Amendment of AC 29-2C

Proposal for Amendment of AC 29-2C

Proposed changes to AC 29-2C

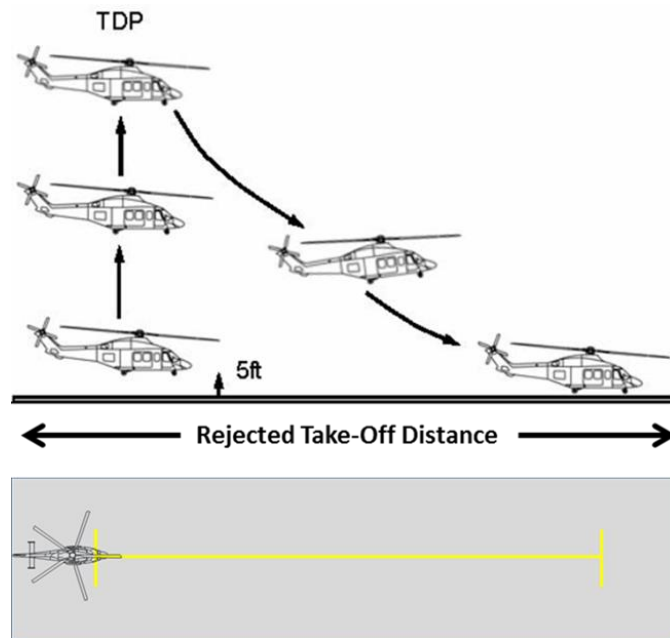
2. Whilst there is adequate advice for the vertical takeoff which includes a run-on (as shown in the diagram below) in the current advisory material in AC 29.59 paragraph b (12)(iv)(A):

“...Establish the rejected takeoff distance as the horizontal distance from the rearmost point of the rotorcraft at the initiation of takeoff to the foremost point after the rotorcraft comes to a stop on the takeoff surface (including rotor tip path), assuming an engine failure in the vertical climb at the TDP.”

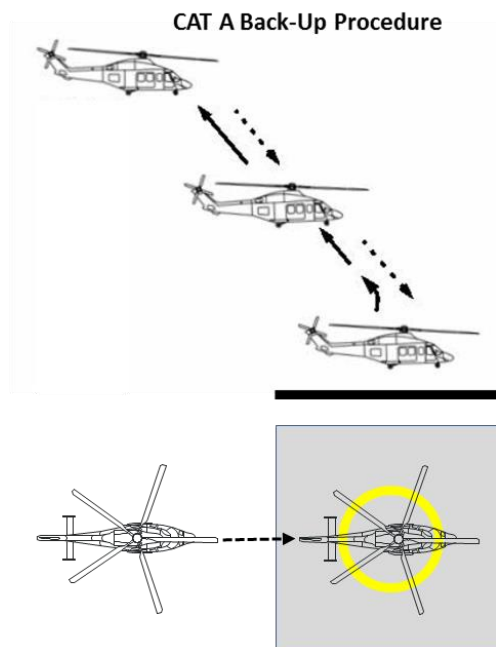
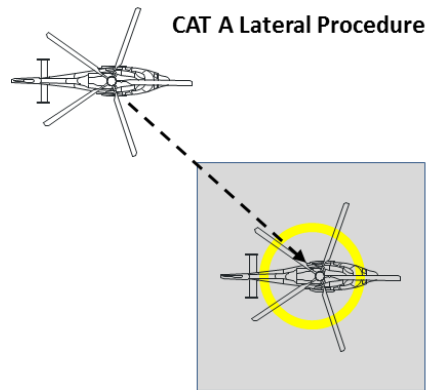
Additional clarity is required to enable applicants to establish the appropriate RTOD for vertical procedures when they are part of a back-up or lateral procedure (both shown below):

In these two cases it might clearer if the existing wording in AC 29.59A paragraph b (12)(iv)(A):

For helipad procedures:

...Establish the rejected takeoff distance as the minimum area into which a rejected takeoff can be carried out, assuming an engine failure in the vertical climb to the TDP. This area should provide containment of all elements of the rotorcraft.

Figure H-1 – S76 showing the absolute minimum undercarriage containment area

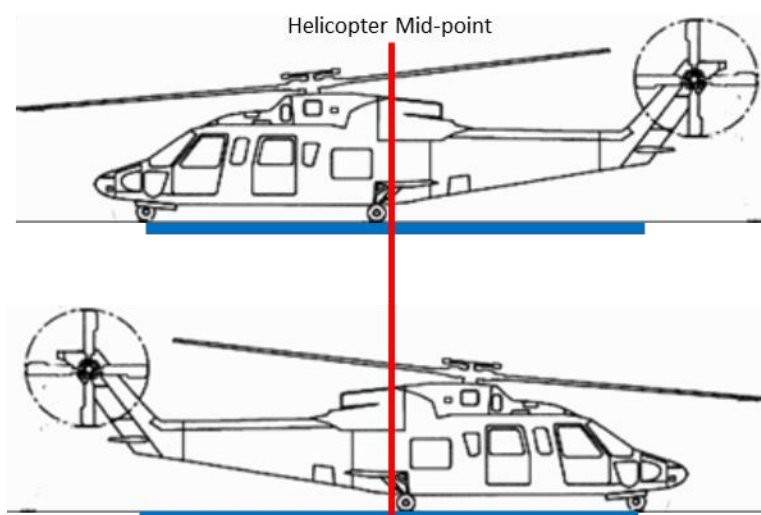
The data arising from the landing scatter must also take account of undercarriage configuration. With a ‘helipad’ procedure³, this will require that landings in all directions be taken into consideration in the provision of the minimum size. As can be seen from [Figure H-1](#), the S76 has an undercarriage that is completely ahead of the mid-point of the helicopter; this will result in an absolute minimum undercarriage containment area of 0.63D. To this must be applied the landing scatter - applicable in a 360° context, before adding the dimensions of the helicopter. It is expected that the minimum size will be expressed as a circle with a diameter that provides the necessary helicopter containment.
